RE: **U-Haul at West Bluff**
Atrisco Drive NW
Grading Plan (Stamp Date 1/30/17) and Drainage Report (Stamp Date 12/5/16)
Hydrology File: H11D059

Based upon the information provided in your submittal received on 2/1/17, the Grading Plan and Drainage Report are approved for Building Permit and Grading Permit.

RE: U-Haul at West Bluff Grading & Drainage (File: H11D059)

Plat of
Tract 306-A
Town of Atrisco Unit 8
Town of Atrisco Grant Projected Section 11,
Township 10 North, Range 02 East, N.M.P.M.
Albuquerque, Bernalillo County, New Mexico
October 2016

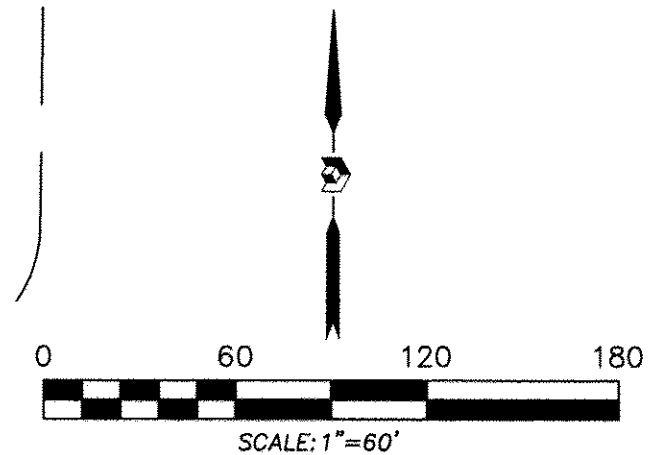
5. A portion of the sidewalk is within the parcel property, if there is no existing sidewalk easement, one will need to be provided.

Response: Additional right of way for public sidewalk was dedicated to the City of Albuquerque by plat (recorded 10/28/2016) for the portions of sidewalk formerly beyond the public ROW. A copy of the plat is attached for reference.

ENGINEER'S SEAL	WEST BLUFF BUSINESS CENTER	DRAWN BY DY
		DATE 1/30/17
	GRADING AND DRAINAGE PLAN	2016061-GRB
	 TIERRA WEST, LLC 5571 MIDWAY PARK PLACE NE ALBUQUERQUE, NM 87109 (505) 858-3100 www.tierrawestllc.com	SHEET # GR-1
RONALD R. BOHANNAN P.E. #7868		JOB # 2016061

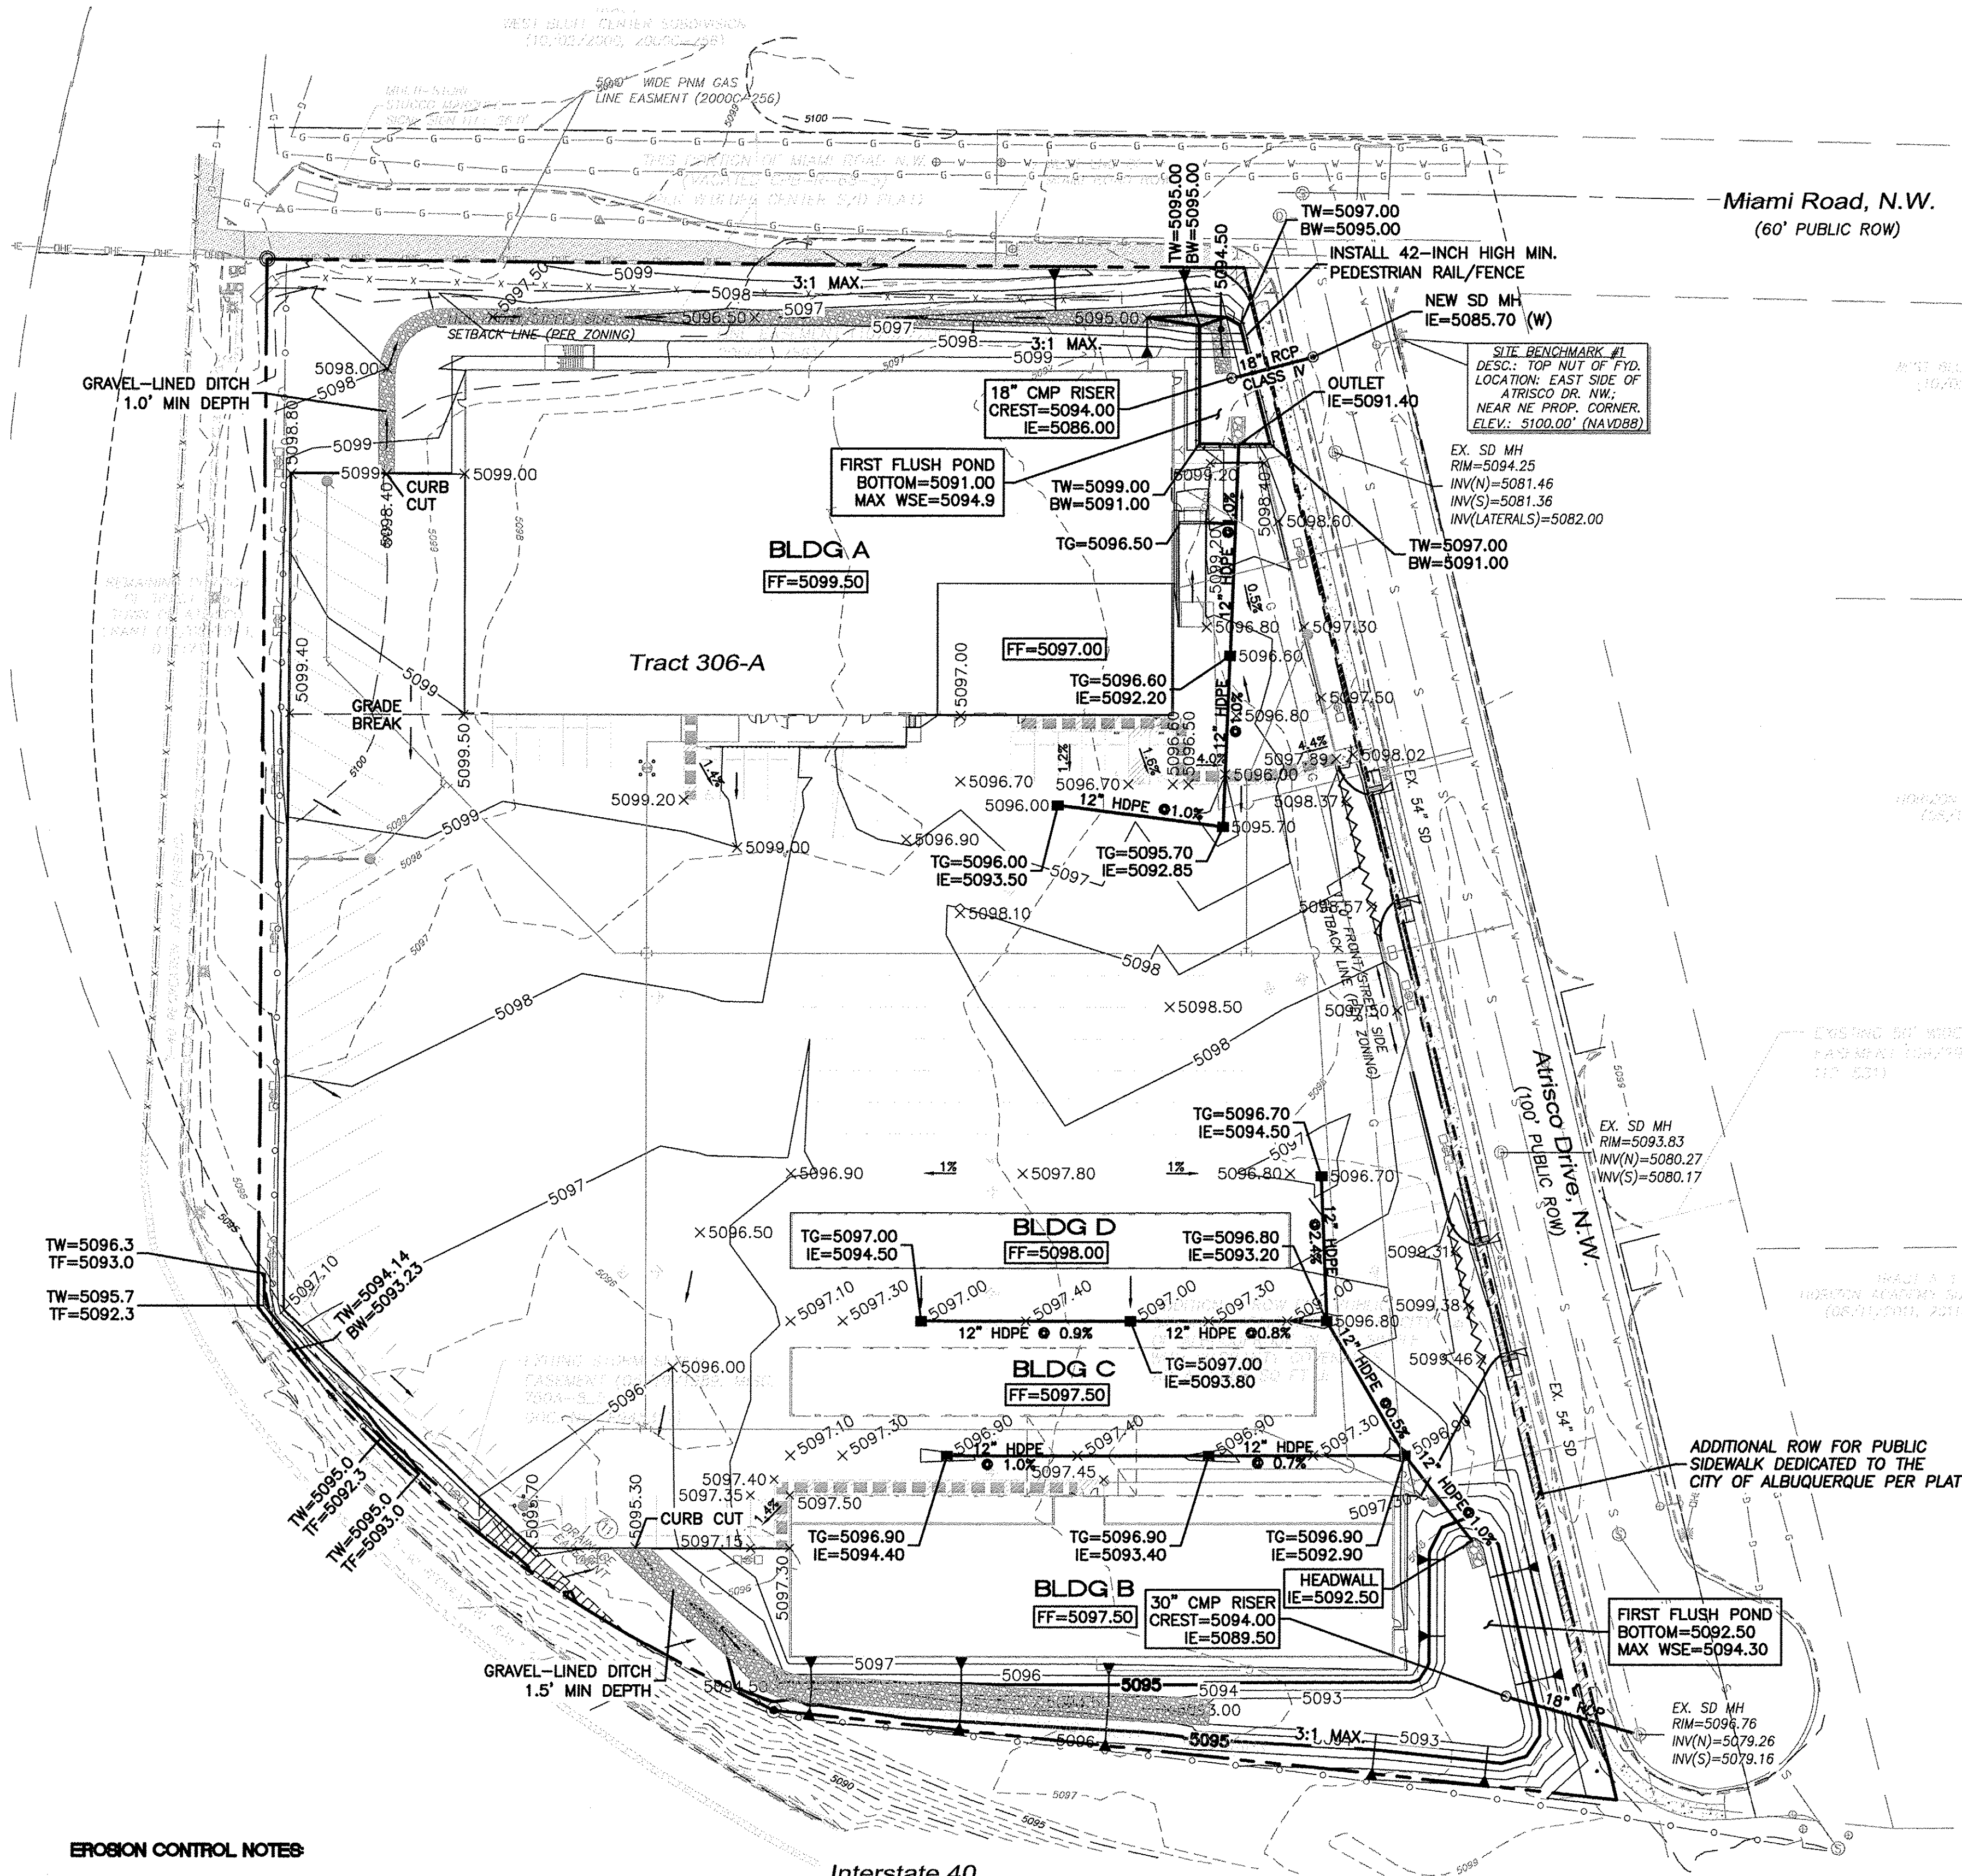
1. The North detention pond appears to be bounded by a CMU retaining wall as high as 8 feet in some places. This will need to be enclosed with a fence at least 42 inches high.

2. Call out Class IV RCP for the north detention pond outfall pipe under the retaining wall.

4. Project Benchmark and Vertical Datum is missing from the sheets. The Drainage Management Plan addresses the NGVD29 to NAVD88 shift, but sheets need this information as well.

Response: We have updated the plan (Sheet GR-1) to include a pedestrian barrier/fence.

Response: We have revised the plan (Sheet GR-1) to specify Class IV RCP for this section of pipe.

Response: We have updated the plan (Sheet GR-1) with a benchmark elevation in NAVD88.

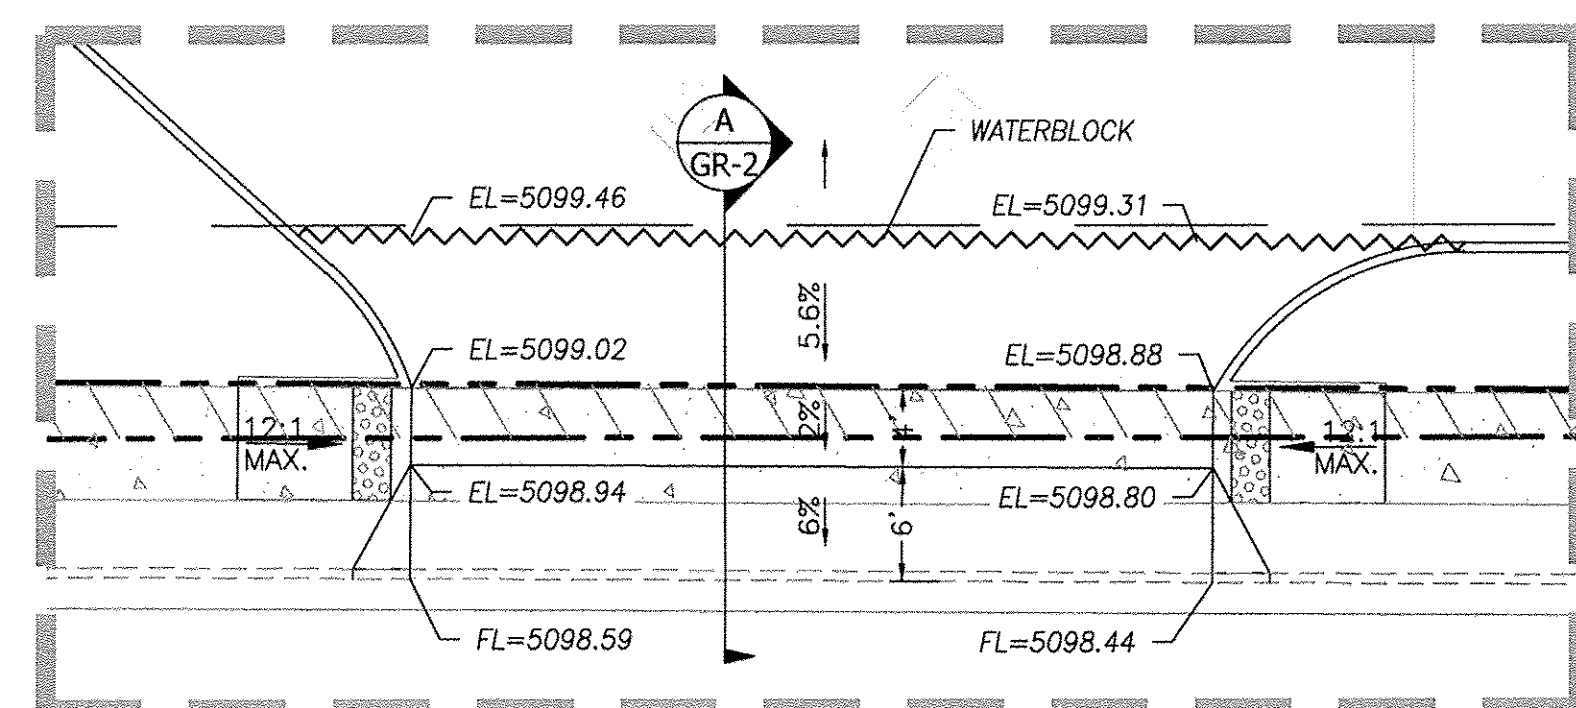
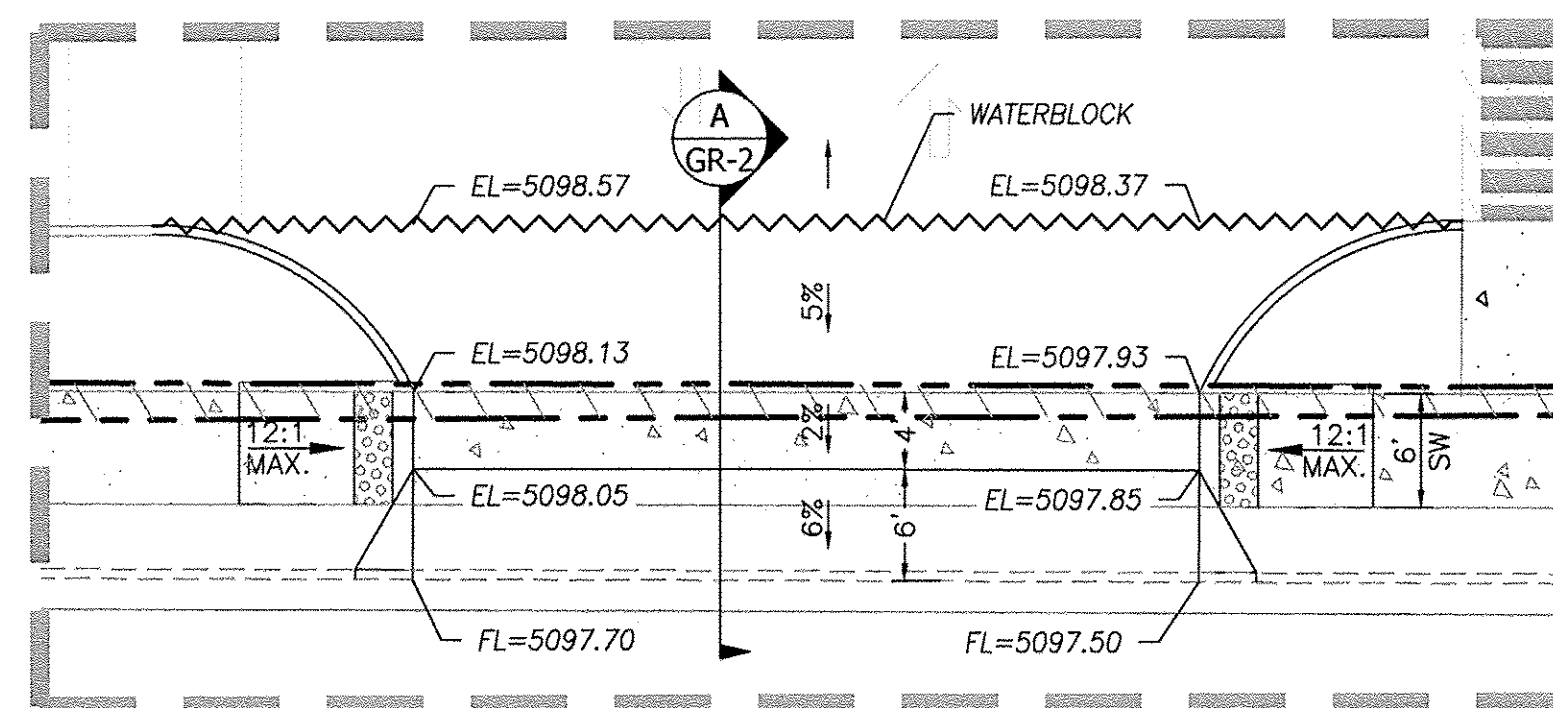
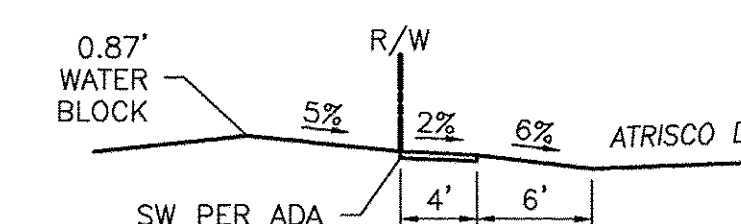
3. Additional detail is required for the two curb cuts and their associated water blocks to ensure ADA compliance for pedestrian traffic along Atrisco. Provide section views at these locations, including flow line elevation, slope, and waterblock elevations.

Response: We have revised the grading plan to show proposed grades for the waterblock and pedestrian paths in greater detail on Sheet GR-2, as requested.
